Annex 3: Scope of Work

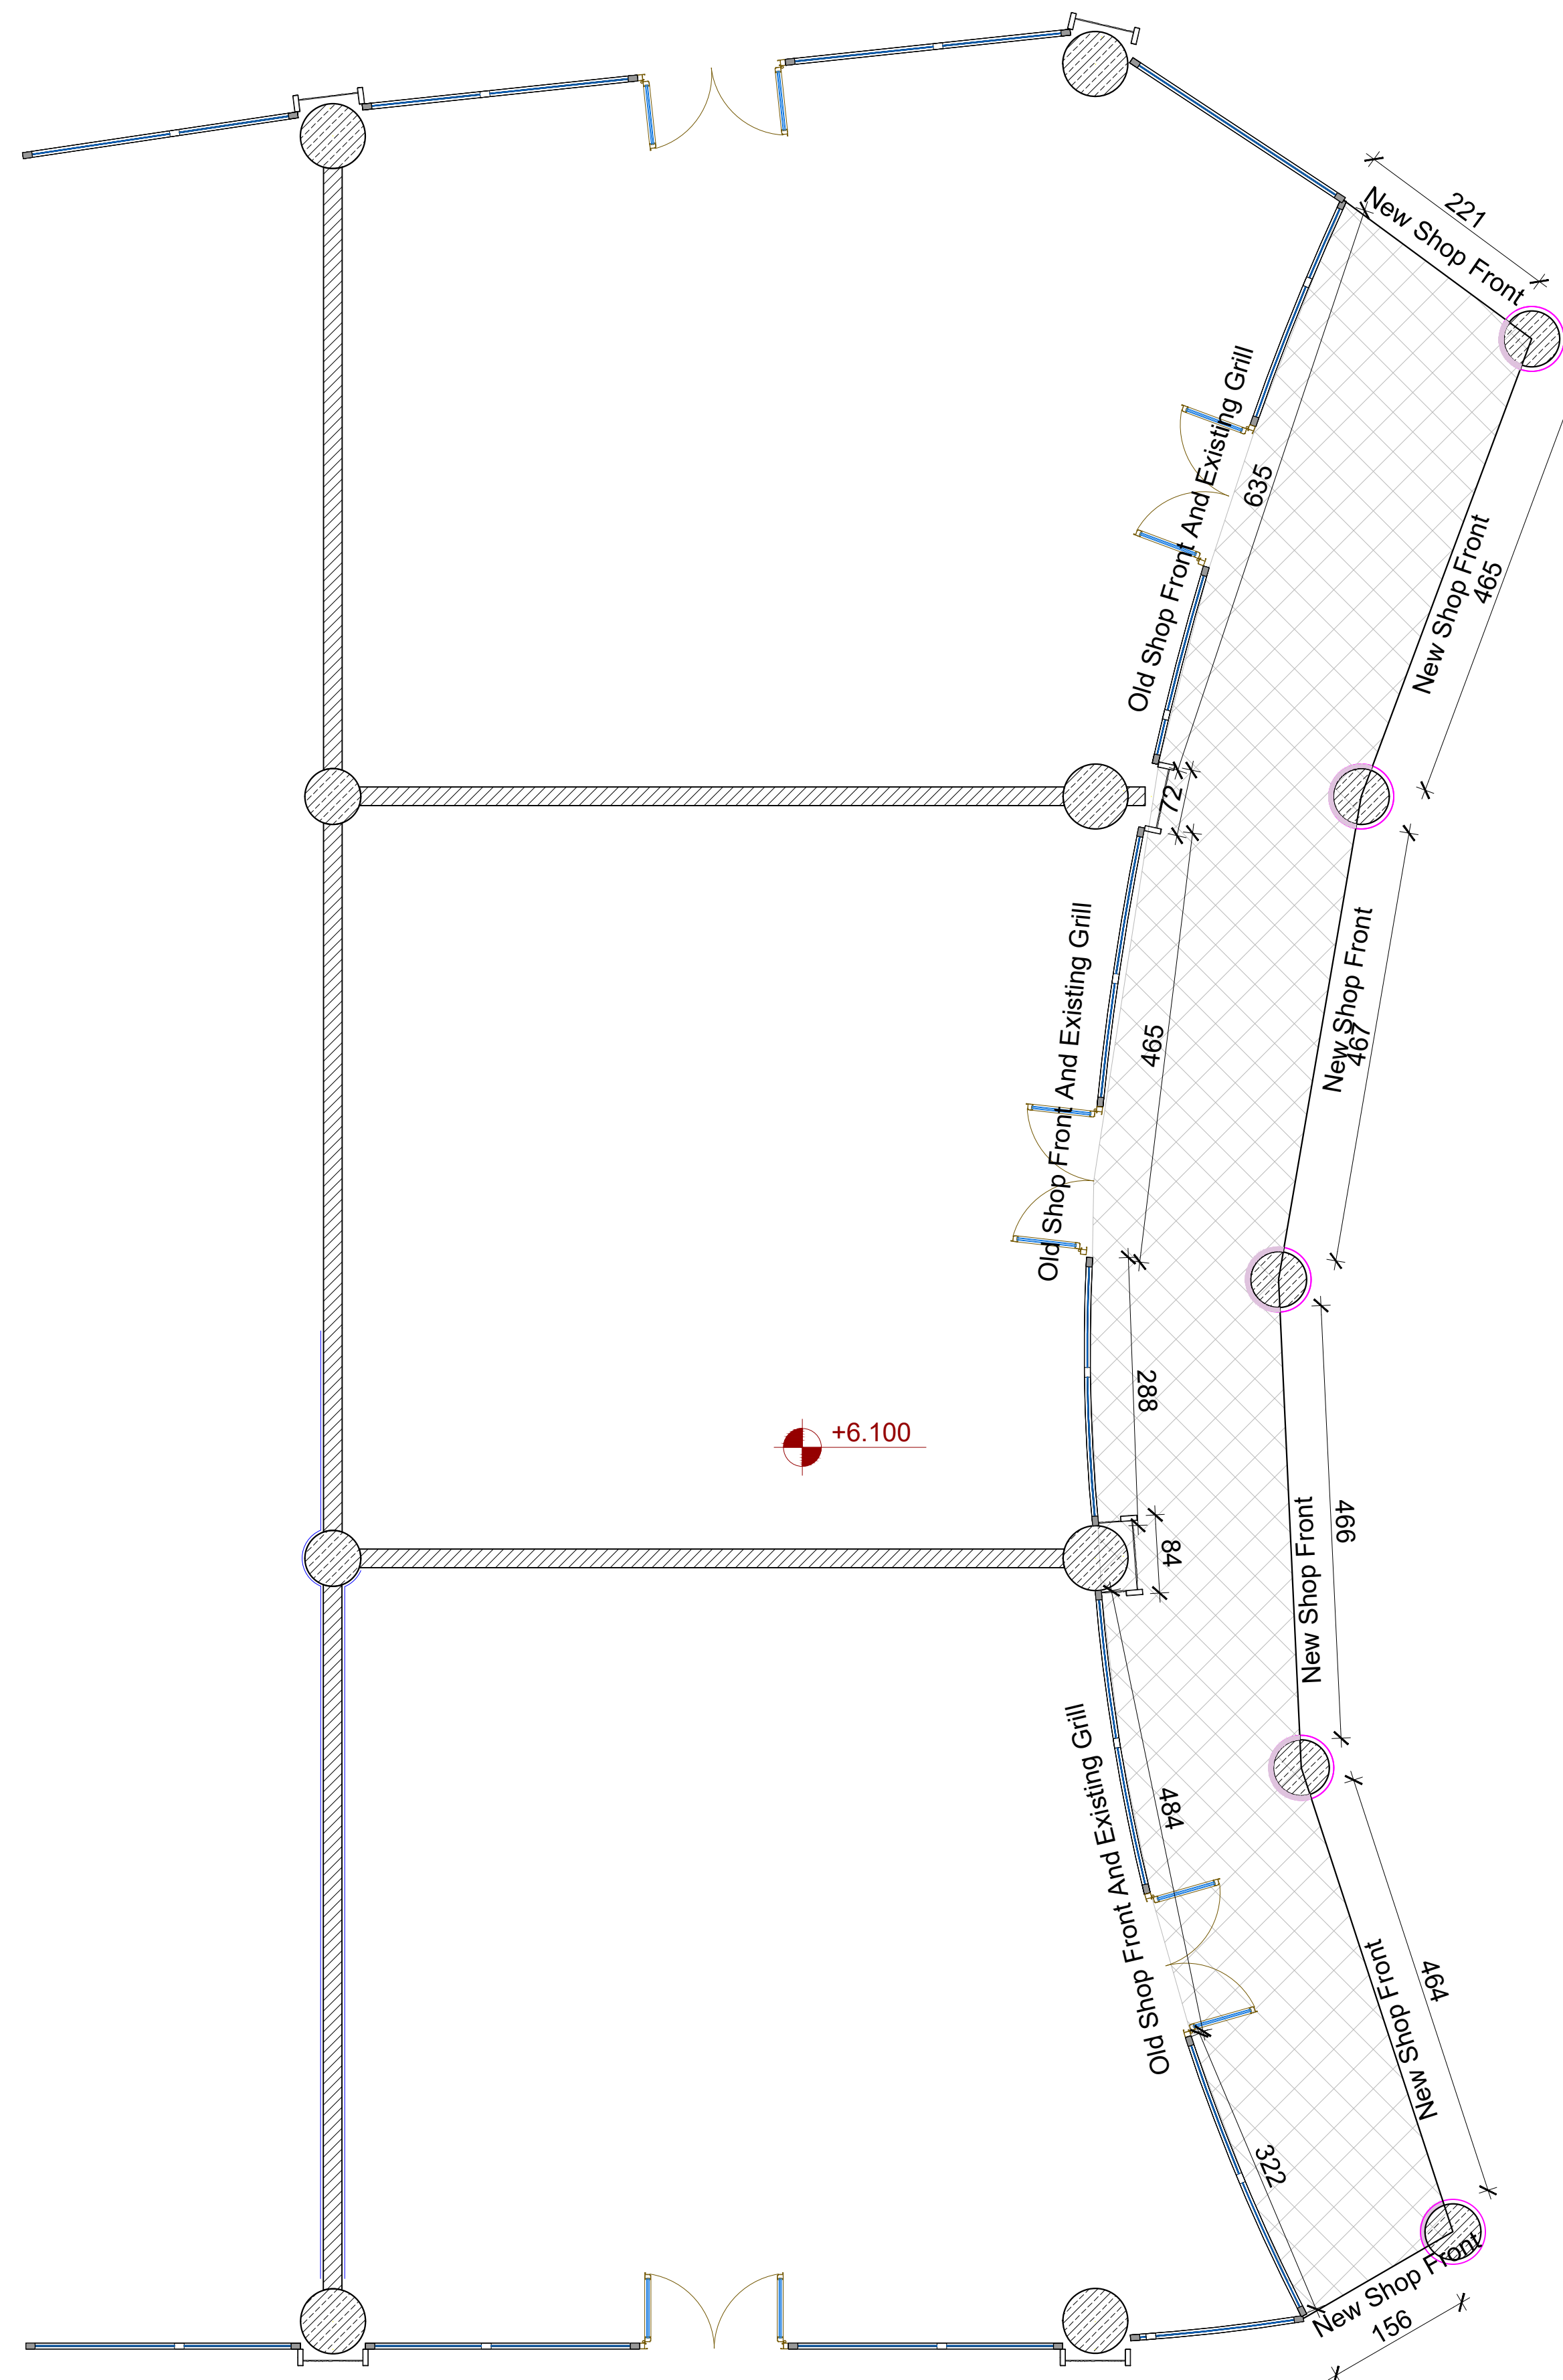
1. **Marked Area of  Suspended Ceiling To Be Removed and Fixed Properly**
2. **Column Cladding  Should be removed Only in Marked Areas**
3. **Grills Above Old Shop Front Should be Relocated above New Shop Front**
4. **Install New Shop Front**
Note: Old Substructure Frame Should Be Used For Relocation
